INDIANA DEPARTMENT OF TRANSPORTATION

MEMORANDUM

RE: Agenda for the April 21, 2005 Standards Committee Meeting

REVISION TO 2006 STANDARD SPECIFICATIONS

506-CCPP-01 Concrete Pavement Patch Details

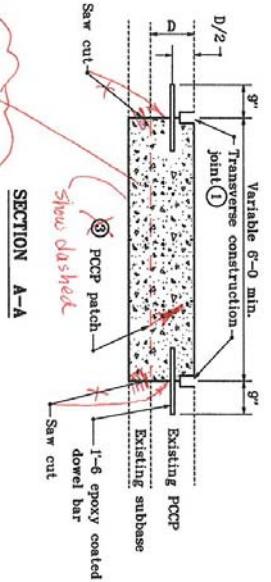
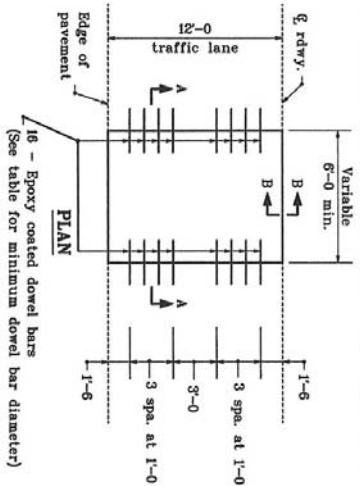
REVISION TO STANDARD DRAWING

*Remove concrete
Symbol 1*

- NOTES**
- See Standard Drawing E 503-CCP-06 for joint seal details.
 - Saw cuts and joint seal shall be omitted if PCCP is to be overlaid.
 - The bottom of the PCCP patch shall be located at the bottom of the existing PCCP subbase or 6" below the bottom of the existing PCCP, whichever is lower.

*Remove concrete
Symbol 1*

INDIANA DEPARTMENT OF TRANSPORTATION									
CONCRETE BARRIER DETAILS									
MARCH 2005									
STANDARD DRAWING NO. E 602-COAB-04

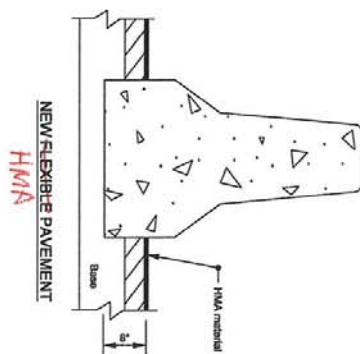
change dowels to #6 Epoxy coated reinforcing steel

Where the concrete barrier is to be placed on PCCP, ~~dowel bars epoxy coated reinforcing steel~~ shall be placed as shown on the plans. The ~~dowel bars epoxy coated reinforcing steel~~ shall be installed in the PCCP by drilling and grouting.
